## S/M Fix: Engine Oil Seal Driver

## ACURA ServiceNews

'01 3.2CL and '99-00 3.2TL, page 7-29:

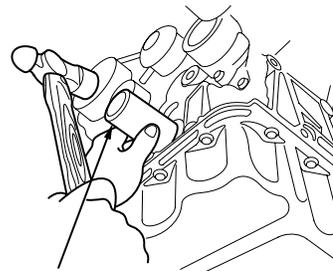
In the engine section of several S/Ms, the oil seal driver used to install the pulley end crankshaft seal has the wrong tool number. The correct number is 07LAD-PT3010A. Here are the affected S/Ms and the pages you need to fix.

**07LAD-PT3010A**

**07LAD-PT3010A**
